**CAMINO REAL REGIONAL MOBILITY AUTHORITY
BOARD RESOLUTION**

THAT the Executive Director be authorized to execute Change Order No. 4 with Jordan Foster Construction, LLC., to add the construction of a retaining wall to Pond #6 of the Eastlake Boulevard Phase 2 Project.

CONSTRUCTION CONTRACT CHANGE ORDER NUMBER

EASTLAKE BLVD.

RETAINING WALL SECTION ABUTTING SHARED USED PATH (3' MIN. TO 6' MAX.)
SCALE: N.T.S.

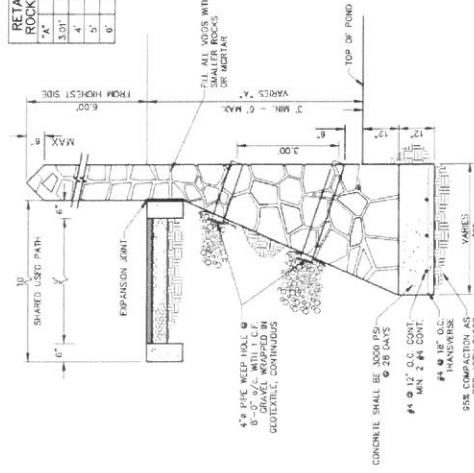
This change order is to pay the contractor to for the construction of a retaining rockwall needed within Phase V – Pond #6 perimeter. This change order will not affect pedestrian elements. No days are to be added by this CO for completing the work. Price for the item was determined to be fair and reasonable.

- STONE FOR ROCKWALL SHALL BE AS NEARLY UNIFORM IN SECTIONS AS POSSIBLE. THE STONE SHALL BE DENSE AND RESISTANT TO AIR AND WATER.
- MORTAR MUST BE TYPE "S" (800 P.S.I.) AS PER ASTM C270.
- WASSTAY WALL OVER SIX (6) FEET IN HEIGHT AND THOSE USED FOR EARTH RETENTION OVER TWO (2) FEET MUST BE DESIGNED AS STRUCTURAL WALLS.
- ROCKWALL MORTAR JOINTS MUST NOT EXCEED TWO (2) INCHES.
- PROVIDE ONE (1) INCH EXPANSION JOINTS AT EVERY 100 FEET.
- ALL STONE SHALL BE THOROUGHLY SOAKED BEFORE BEING PLACED.
- ALL STONE FOR ROCKWALLS SHALL BE FRACTURED QUARRIED ROCK.
- WORKING SURFACE SHALL BE AS NEARLY VERTICAL AS POSSIBLE.
- ALLOWABLE SOIL BEARING PRESSURE = 2,500 PS (MINIMUM).
- BACKFILL MATERIALS SHALL CONSIST OF COARSE GRAINED, WELL-DRAINED SOILS (WITH NO CLAY CONTENT).

PONDING AREA 6

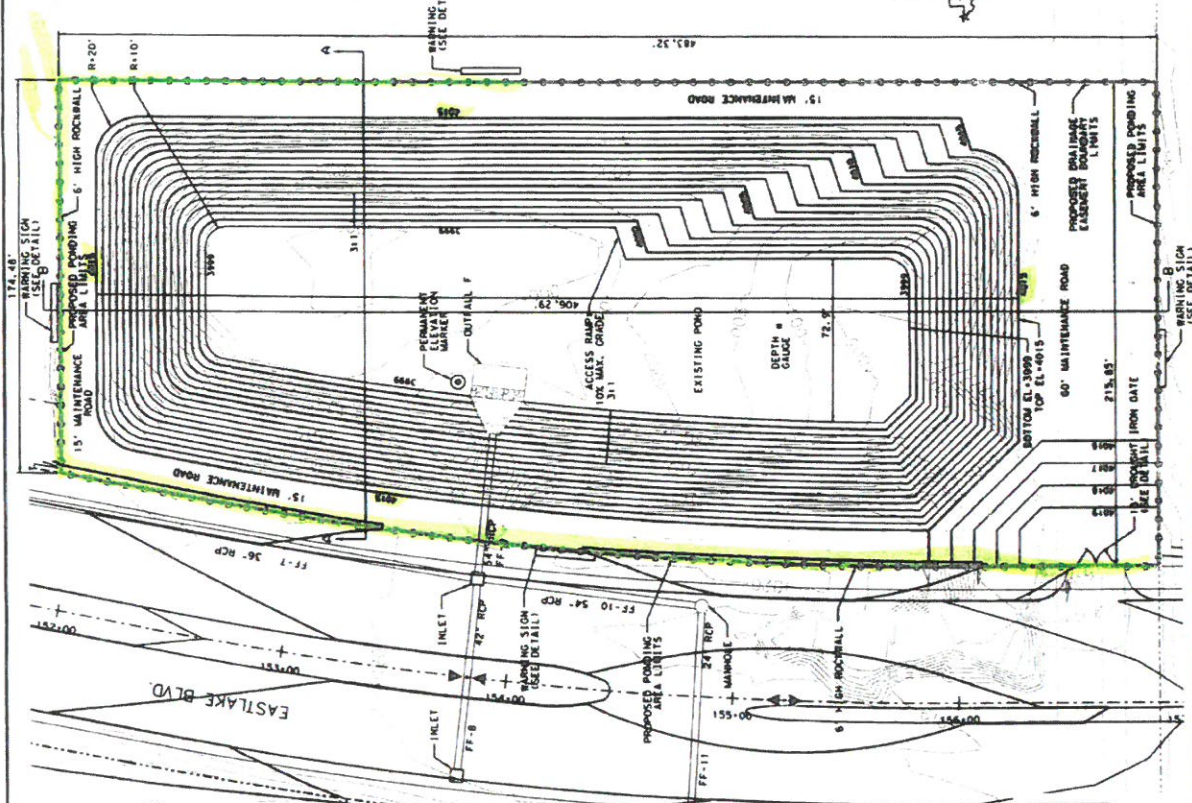
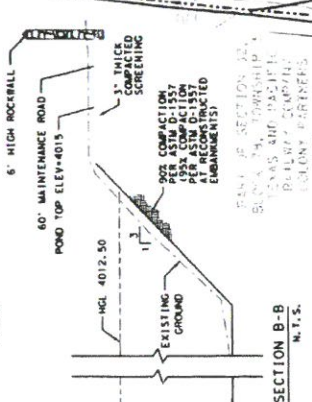
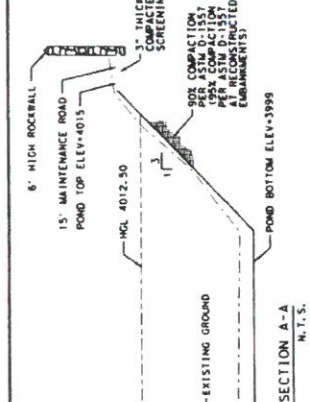
WHEREAS, an issue has been identified related to elevations in and around Pond #6, and the parties desire to construct a retaining wall to address such elevation issue; and
